**Re: Proposed Amendments to Land Use Bylaw 1P2007  
PUD2019-0402**

Subject: PUD2019-0402

A proposal to PUD2019-0402 amendments.

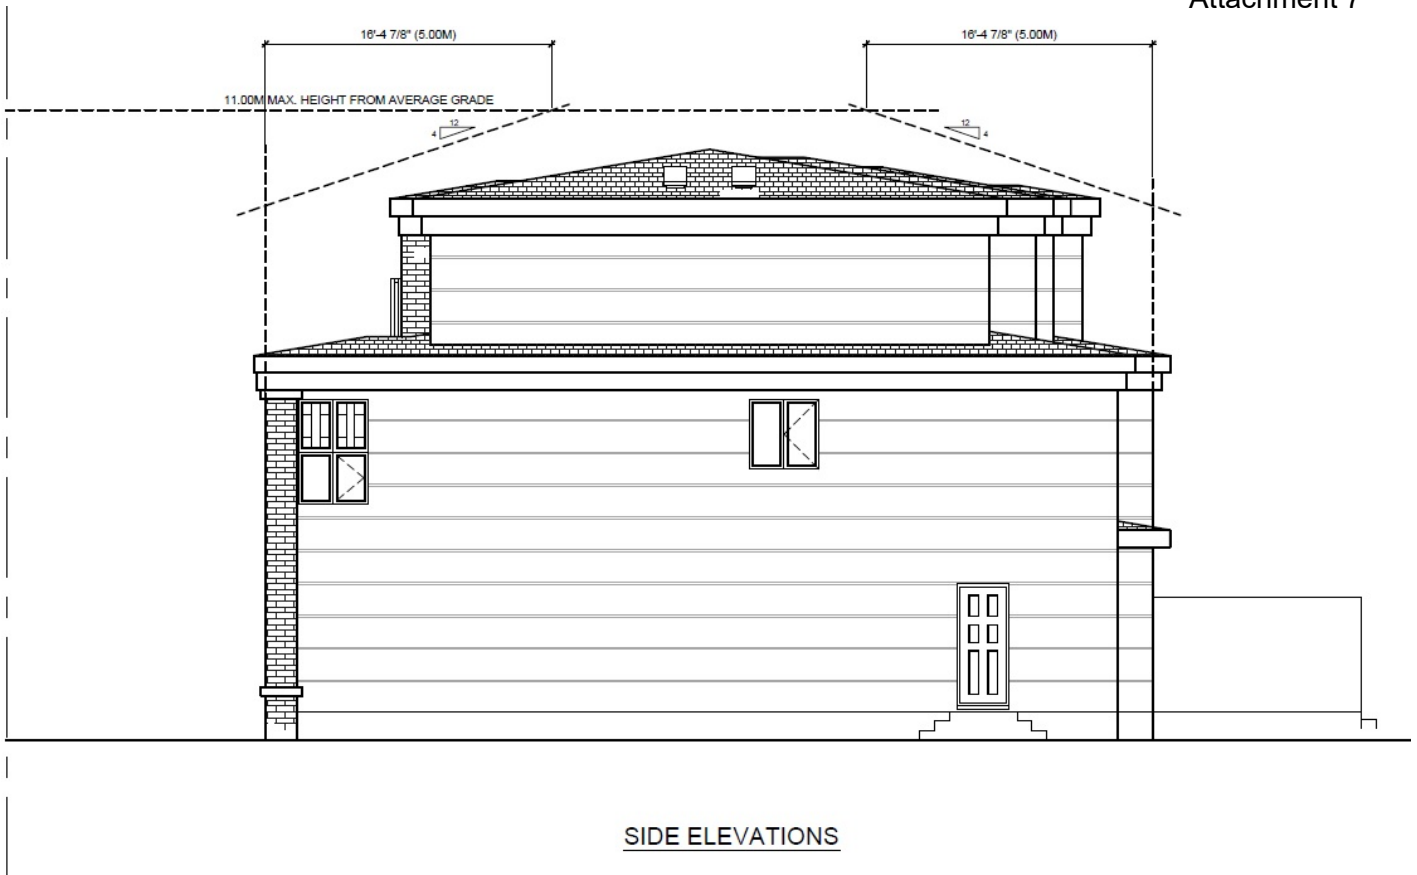
This above example is for a street side and a bungalow. The 11 m is consistent and a side chamfer at 7.6m allows for various build forms but the build forms still have to be inset to break up massing. In this example, the street side going straight up encroaches into the chamfer and should not be allowed. The right side steps in breaking the massing and conforms. We have picked 7.6m for all scenarios to work and the indents would still be close to 1m depending on ceiling heights.

This above example is for a bungalow on both sides. The 11 m is consistent and a side chamfer at 7.6m allows for various build forms but the build forms still have to be inset to break up massing. In this example, the left side going straight up, once again encroaches into the chamfer and should not be allowed. The right side steps in breaking the massing and conforms. Again, we have picked 7.6m for all scenarios to work and the indents would still be close to 1m depending on ceiling heights.

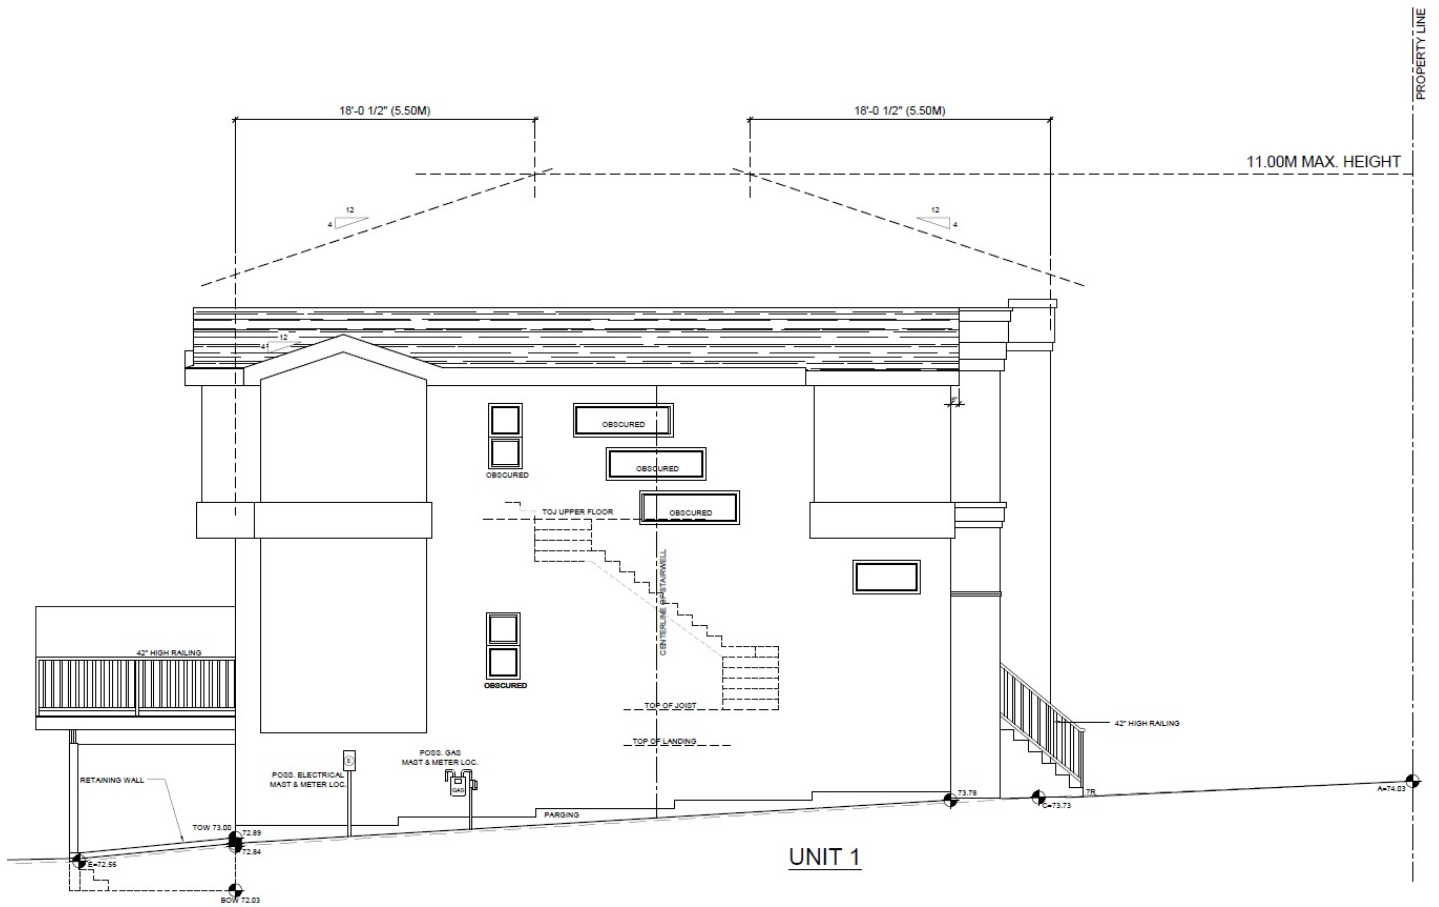
This above example is for a two storey on both sides. The 11 m is consistent and a side chamfer at 7.6m allows for various build forms but the build forms still have to be inset to break up massing. In this example, the left side going straight up still encroaches, and the building would still have to be articulated, even next to a two storey, but the rule is the same for all scenarios. This still allows for various build forms but not block massing.

This proposal for side chamfers would also have to include provisions to inset the back and front of a 3<sup>rd</sup> storey as well. Taking the same building as shown above, but looking at the side building form, take the furthest most foundation line, extend that line up to the 11m, measure back 5.5m back and front along building height line, take a 4/12 slope down from that point to front and rear property lines. Again this ensures that an inset is required if the developer wishes to go to a 3 storey product and works for all scenarios, regardless of build form existing beside the subject parcel.
